**TOWN OF MOUNTAIN VILLAGE
REGULAR DESIGN REVIEW BOARD MEETING
AGENDA**

3.	10:05	60	Miller	Quasi-Judicial	Consideration of a Design Review: Initial Architectural and Site Review Application for a new single-family residence on Lot AR-2, 113 Lawson Overlook, pursuant to CDC Section 17.4.11. This item was continued from 3.26.2020 and 5.7.2020.

4.	11:05	60	Miller	Quasi-Judicial	Consideration of a Design Review: Initial Architectural and Site Review Application for a new single-family residence on Lot 601, Knoll Estates Unit Two, pursuant to CDC Section 17.4.11. This item was continued from 5.7.2020.

FROM: John Miller, Senior Planner

Grading
and
Drainage
Plan

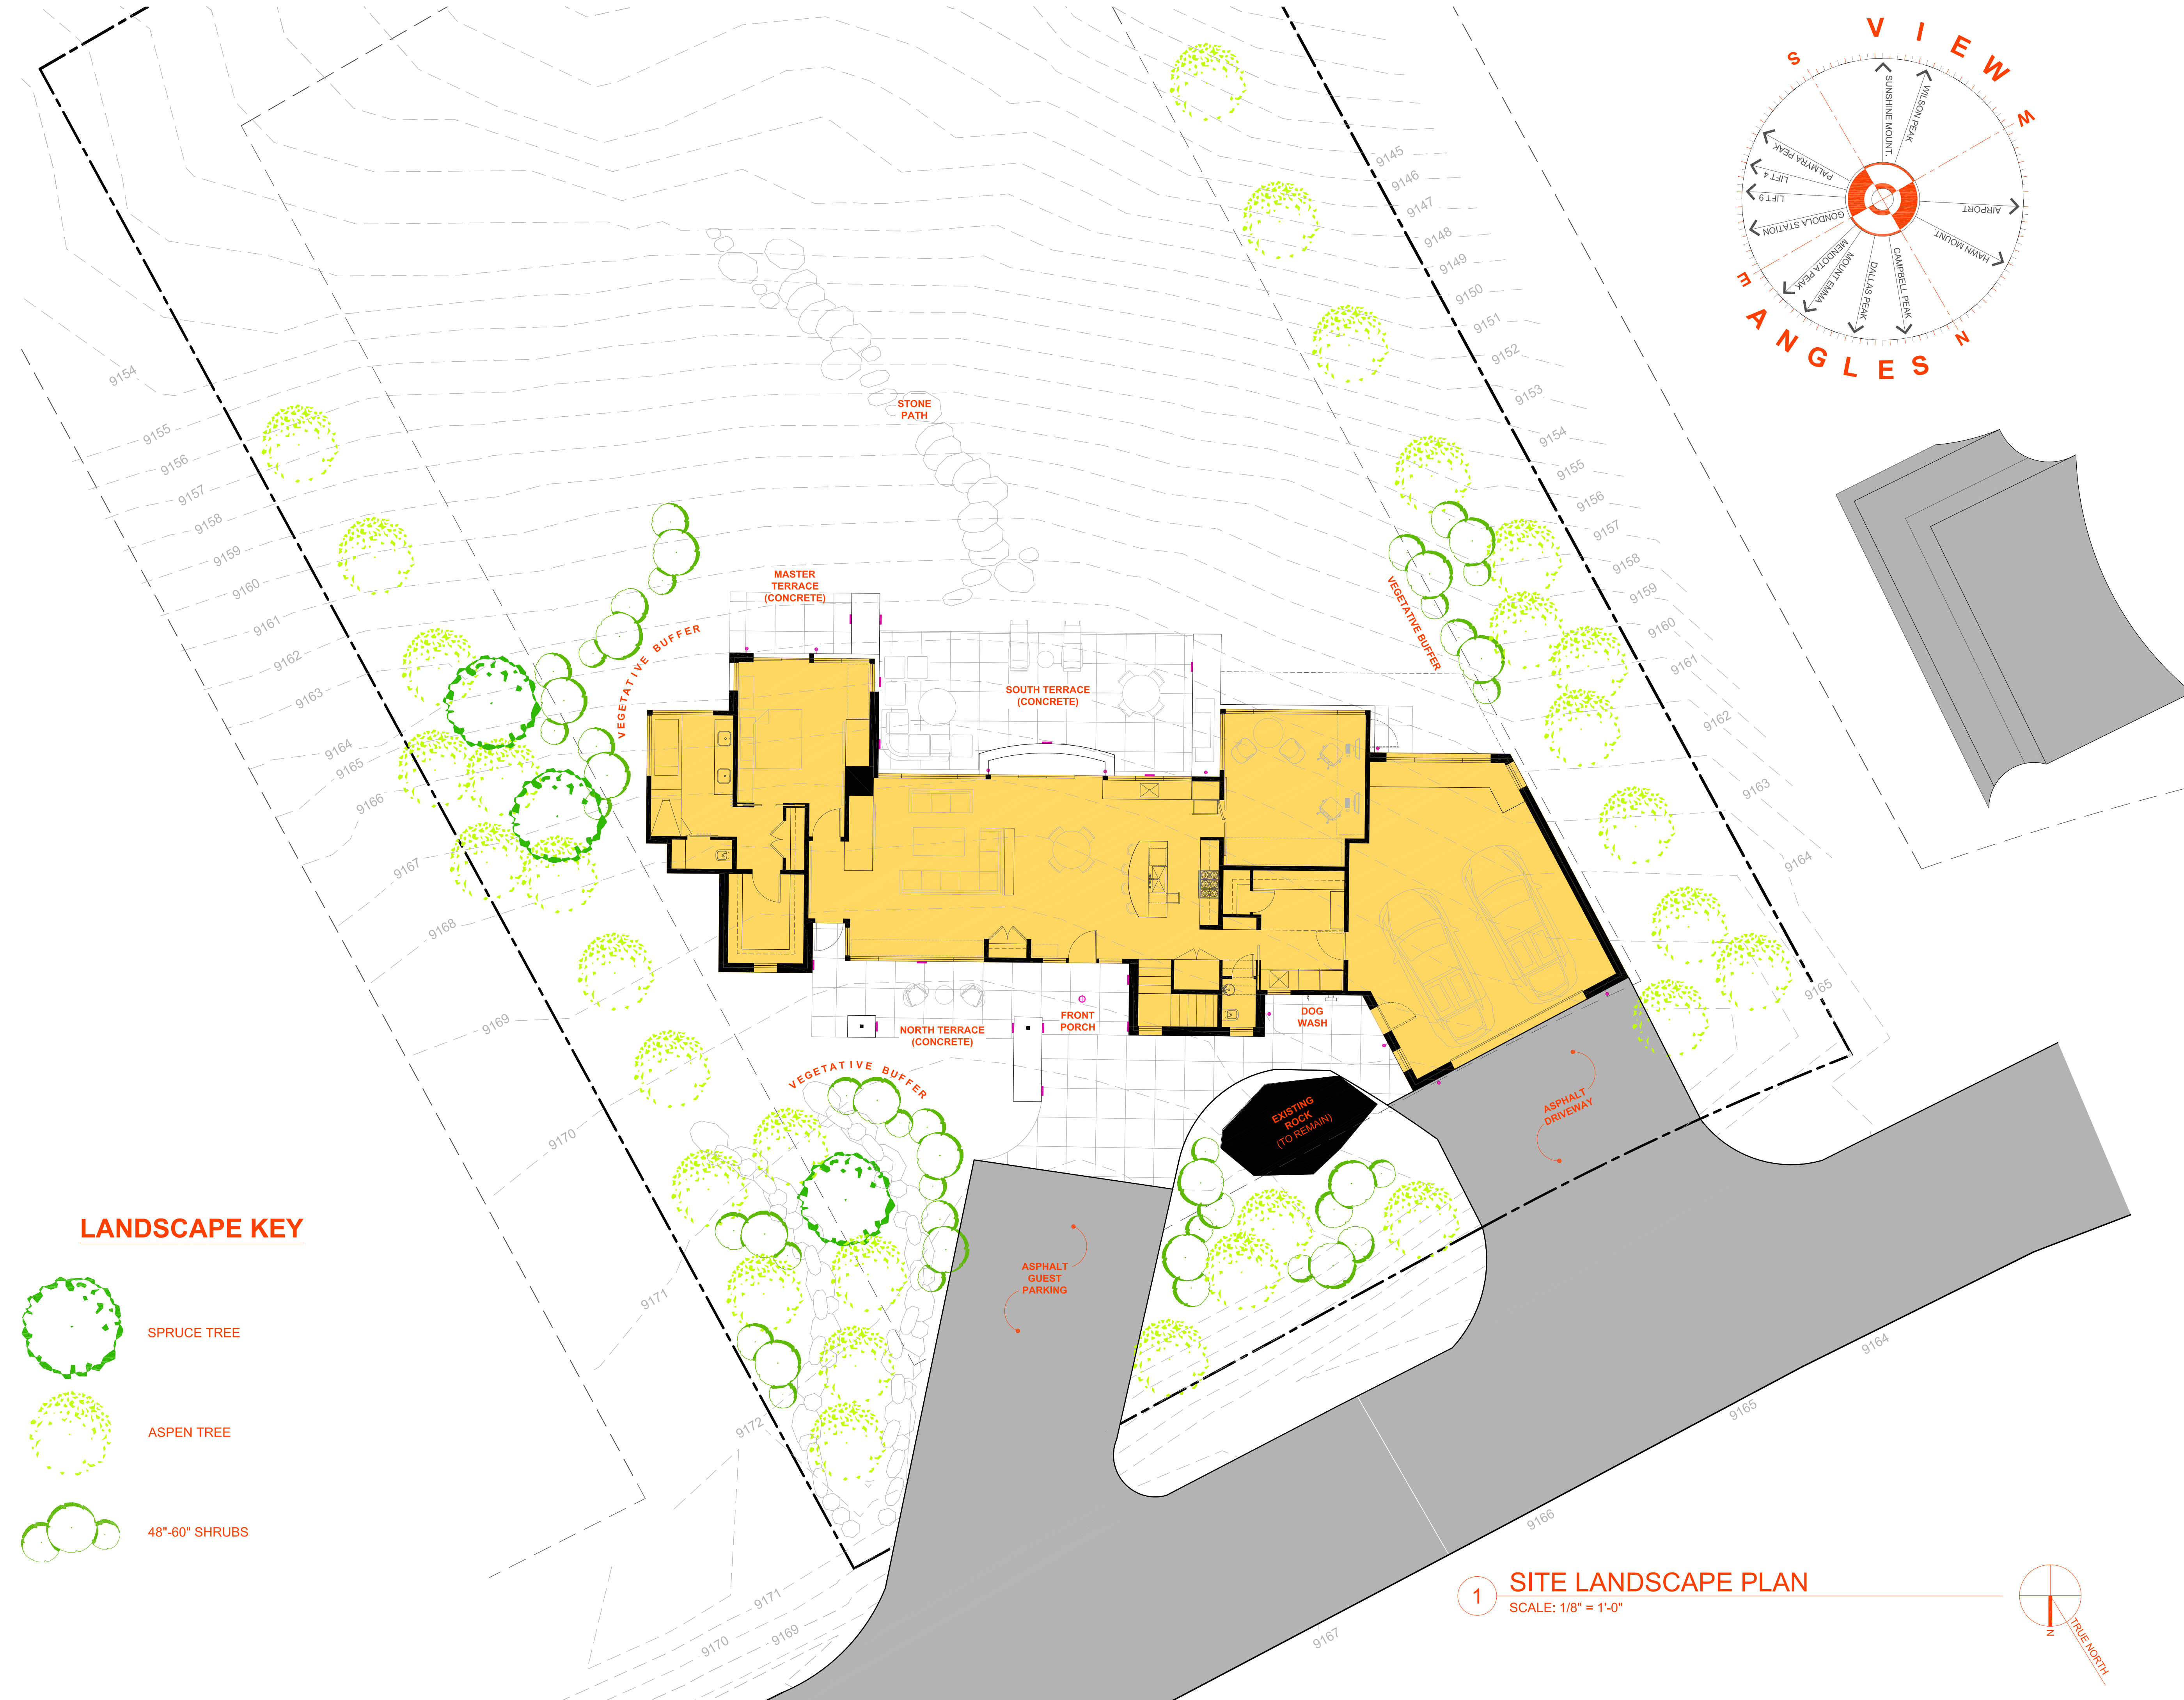
Staff: The applicant has provided a grading and drainage plan documenting disturbed areas, cuts, fill, final slopes adjacent to the home, stormwater design including positive drainage from proposed home, and specifications of the retaining walls that are necessary to construct the home's driveway.

SITE LANDSCAPE PLAN

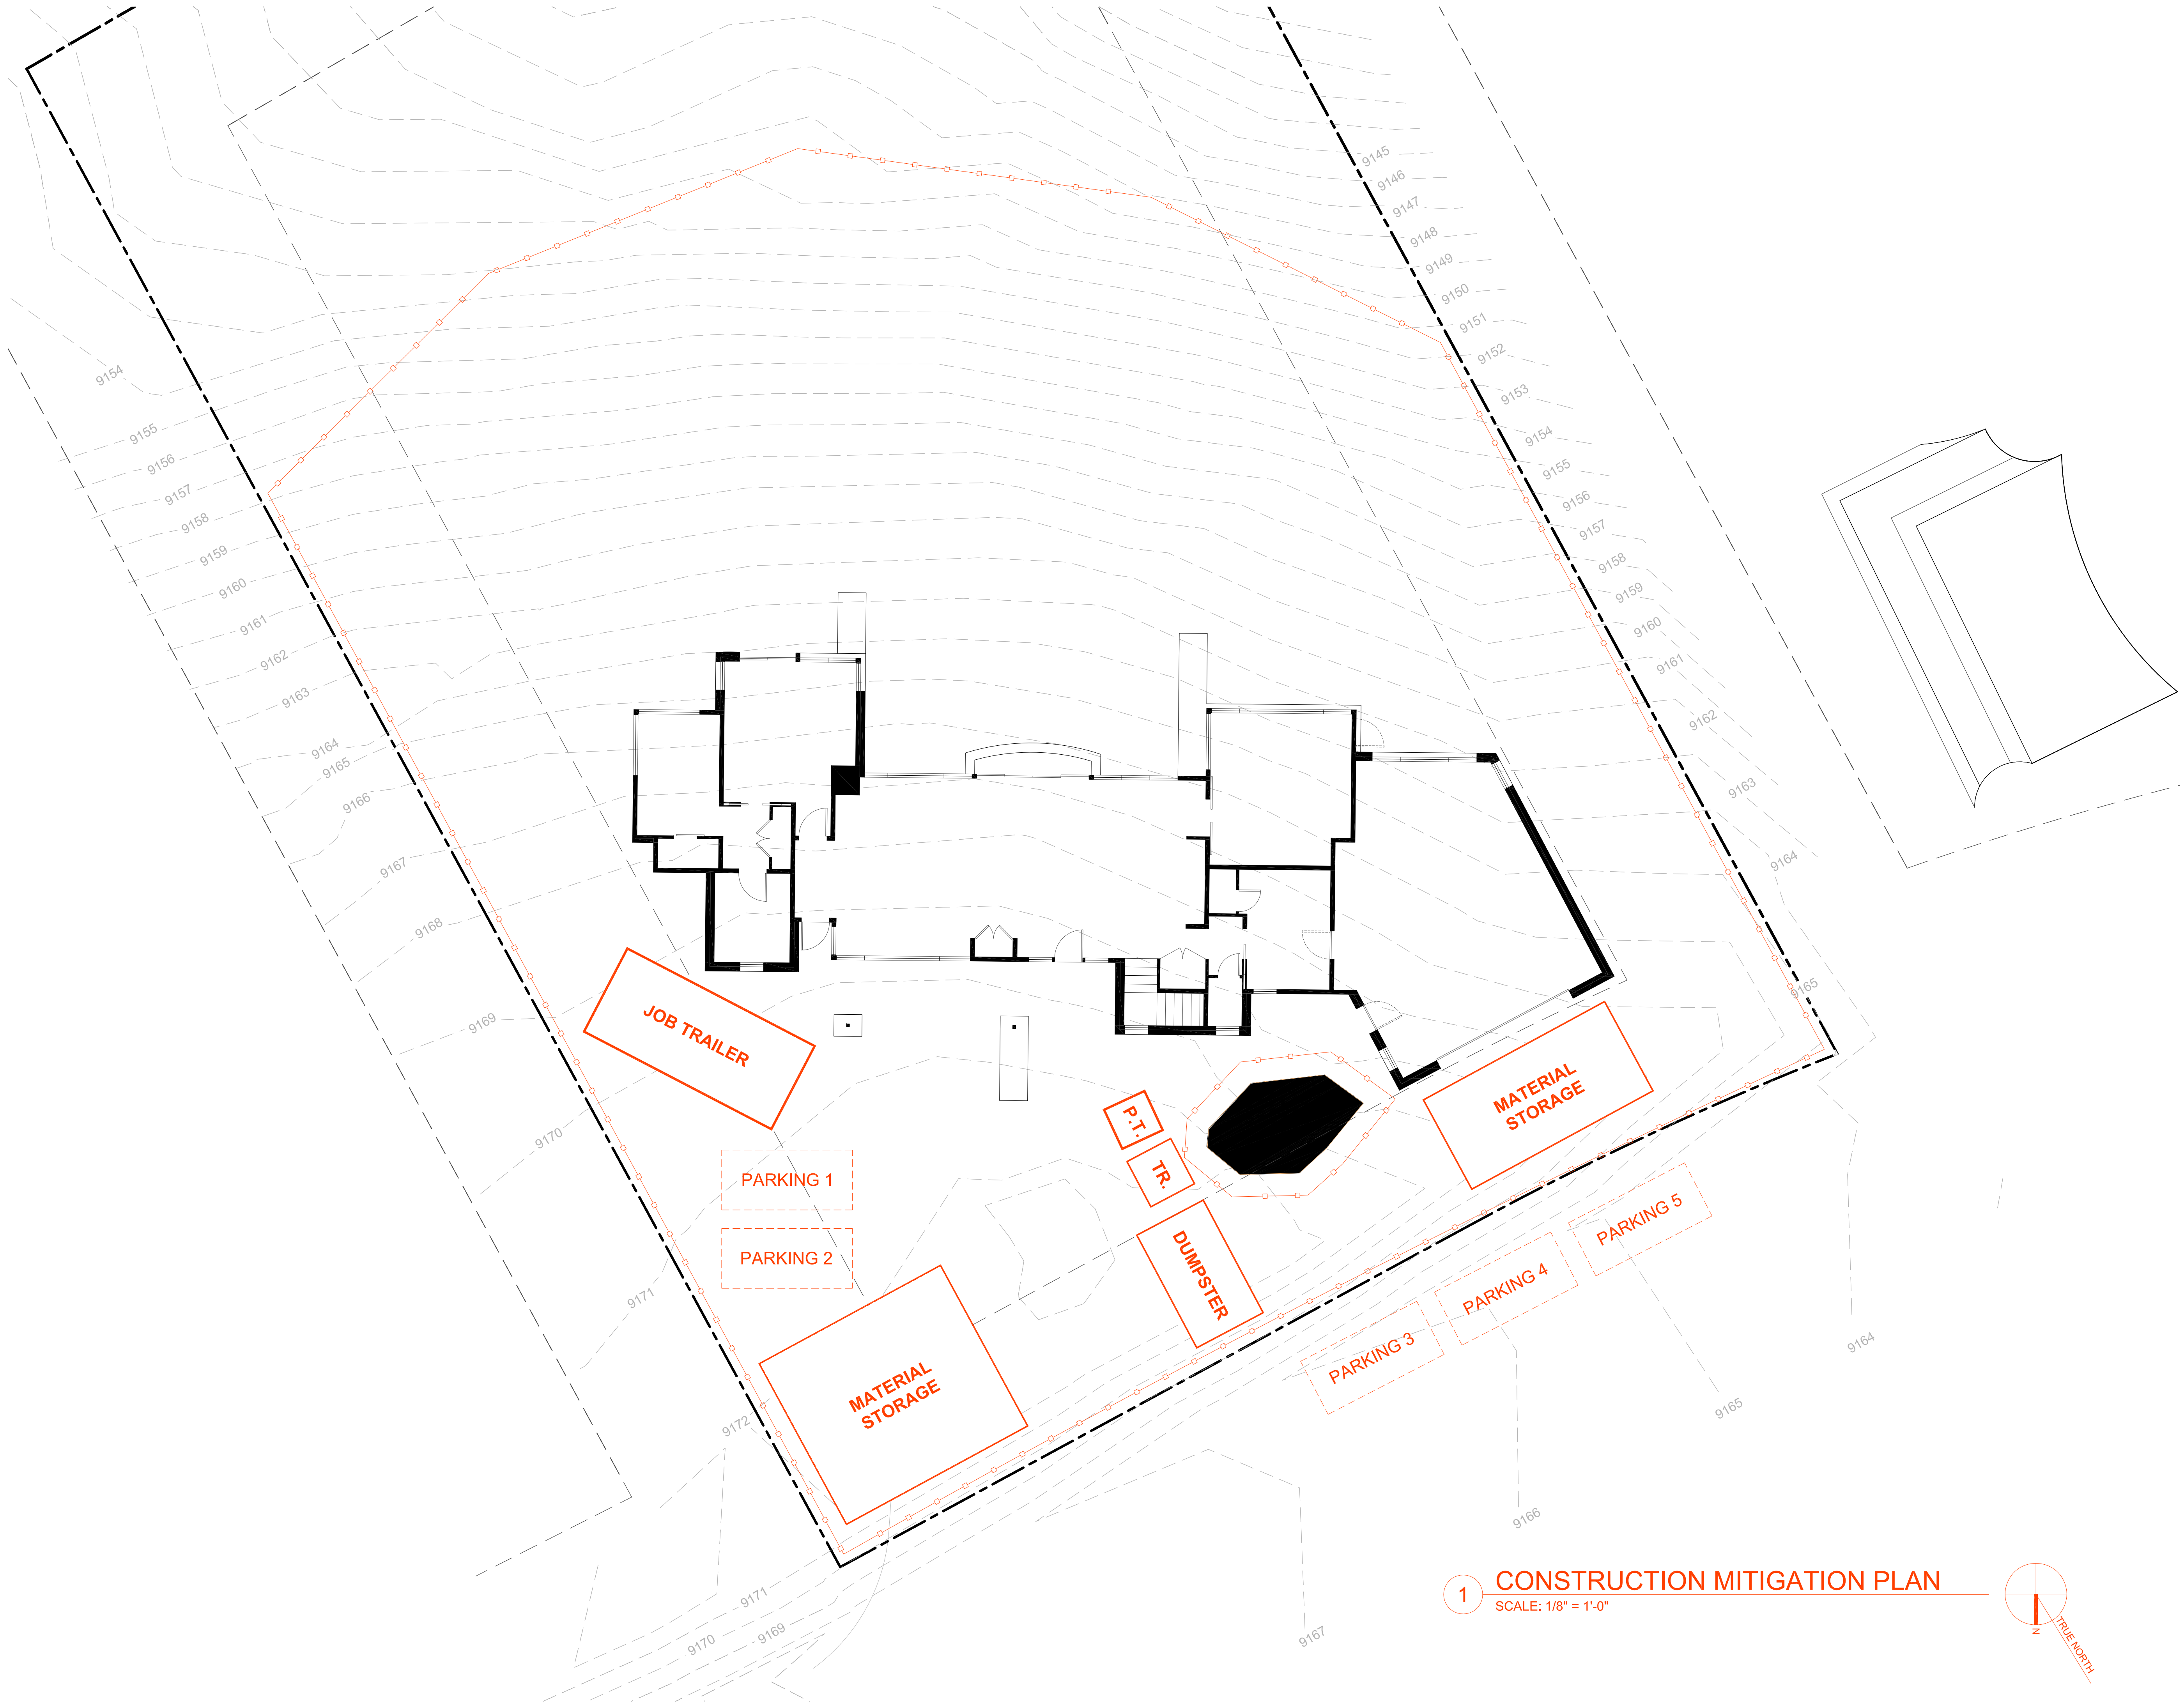
The applicant has provided a preliminary landscaping plan demonstrating the areas to be landscaped and the species. Before the final review submittal, the applicant must provide more details related to the planting schedule including details on the species, number, size, and method of installation/maintenance. Also, the applicant will be required per a condition of approval to revise the landscaping plan to remove all coniferous trees located with the Zone 1 Fire Protection Area that extends 15 feet from the perimeter of the home. These trees and shrubs may be replaced with deciduous trees and shrubs or removed in their entirety. The landscaping plan shall show all irrigation areas, shut off valves, revegetation notes, and any areas of turf that may be proposed for Lot AR2.

- 4) Prior to the submittal for a Final Architectural Review, the applicant shall provide an updated landscaping plan demonstrating all areas located within the Zone 1 Wildfire Mitigation Area, along with modifying their plans to remove all coniferous species within Zone 1. Also, the applicant shall demonstrate all areas to be landscaped with the specific planting and irrigation schedules.
